RE: 29 Elizabeth Building updated elevation for planning board review

REVISED BUILDING ELEVATIONS - 1
ALTERATIONS LEVEL 2 & ADDITION
JEFF & MINDY HAYES, 29 ELIZABETH ST., ELLICOTTVILLE, NEW YORK 14731

S3
23JHS1

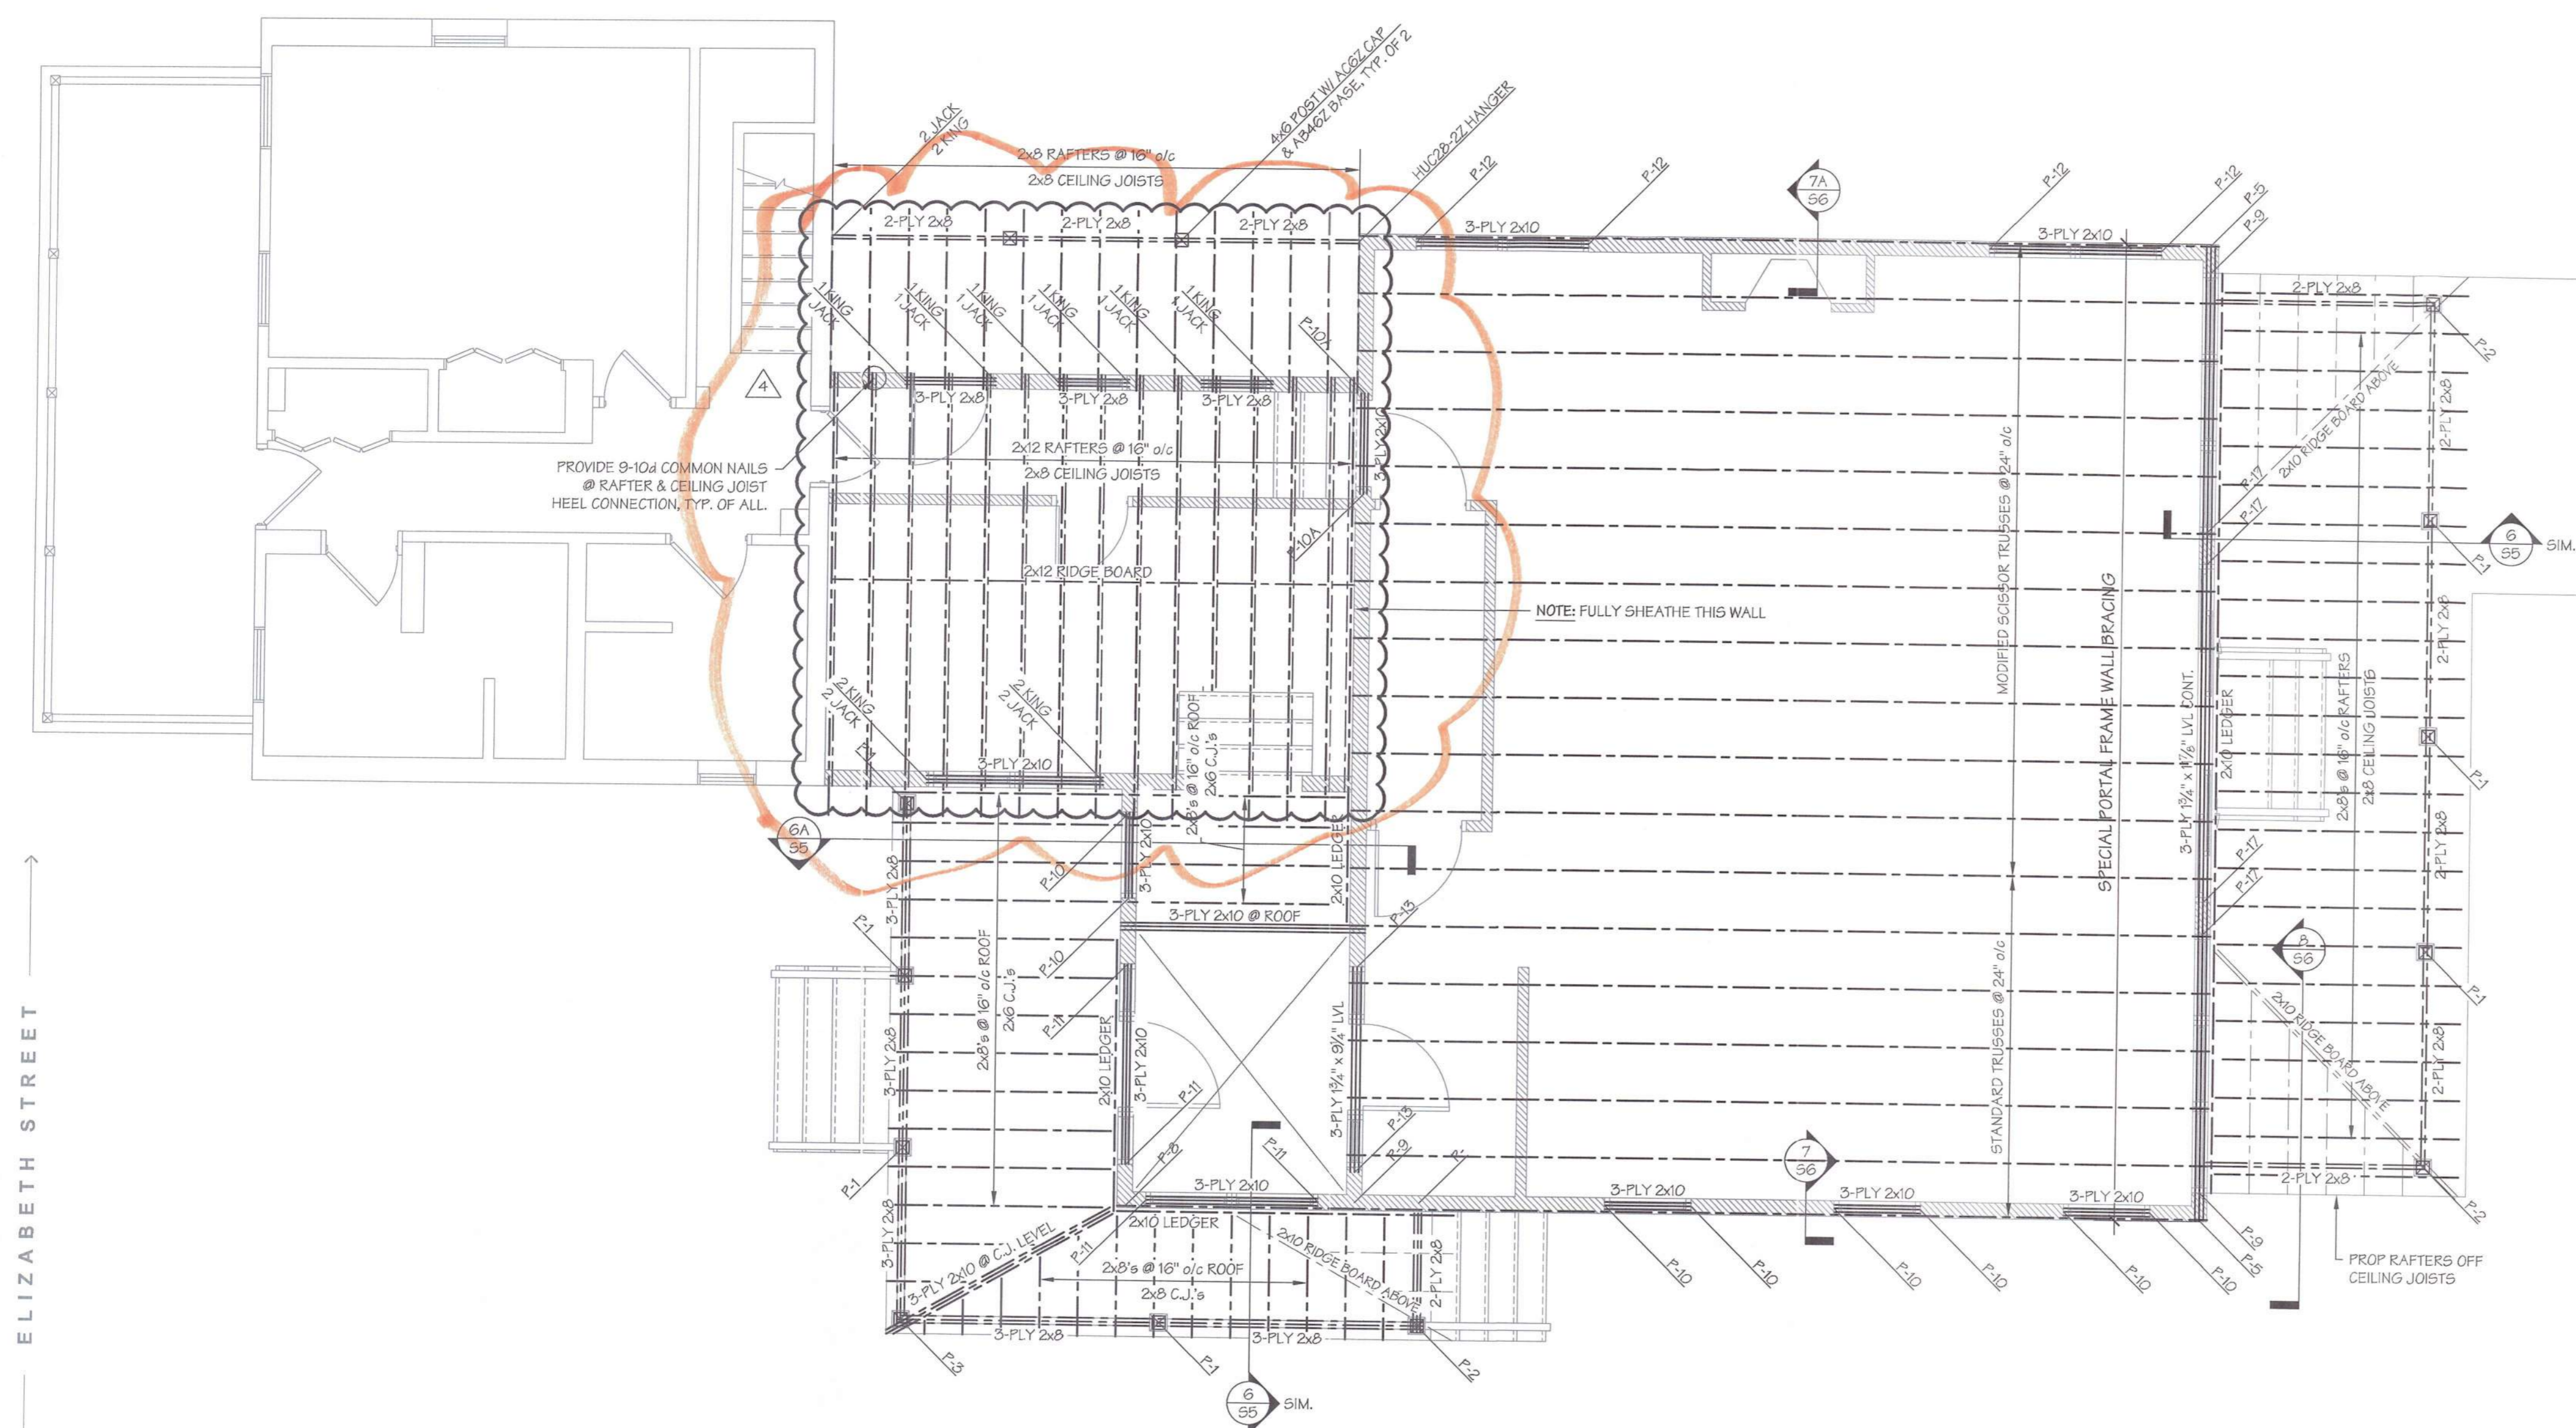
- 7) Drawing S3 dated 6-9-23 showing no structural work in the connection section of the original house.
- 8) Drawings S3 dated 12-27-23 showing the additional reinforcing and structural work that was required for snow load.

- 1) The connector section of the old house was in such structural disrepair we were given direction to remove and rebuild as detailed on updated structural drawings formalized on drawing S3 dated 12-27-23.
- 2) We made the changes to the window because the transom windows did not fit as designed and we elected to use that unused window in the mudroom.
- 3) Once we realized the connector section was completely rotted out we elected **not** to reinstall a new deck that was in the original design. Frankly to save some money that we did not expect to spend on the connector.
